**Amendments to the Drawings:**

Method and System for Assisting in Backups and Restore  
March 31, 1998 / Docket No.: EMC-97-137  
Robert Kevin Perkins, Esq. (Reg. No. 36,634)  
November 20, 2002

FIG. 3

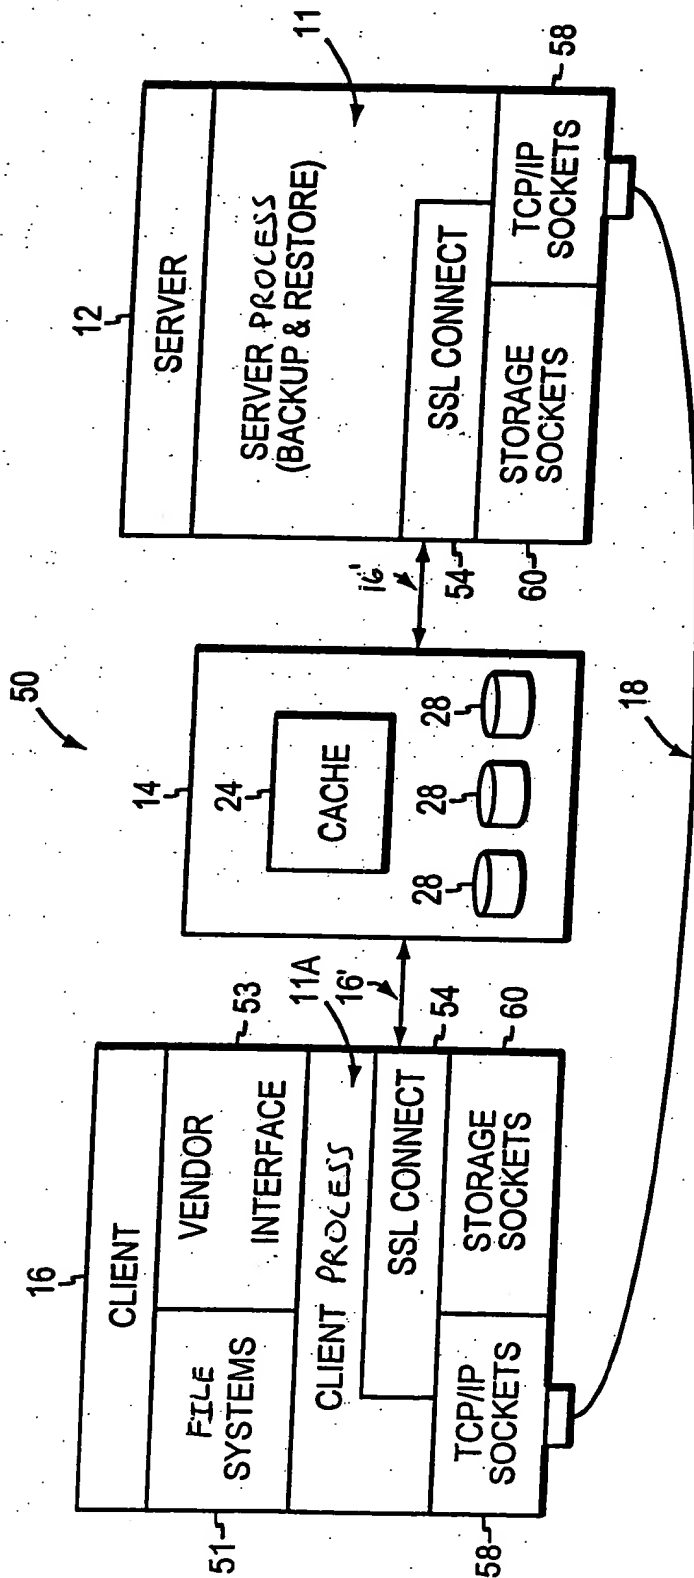
In Fig. 3, “EDM” was deleted from both of boxes 54 to make the figure consistent with the Specification.
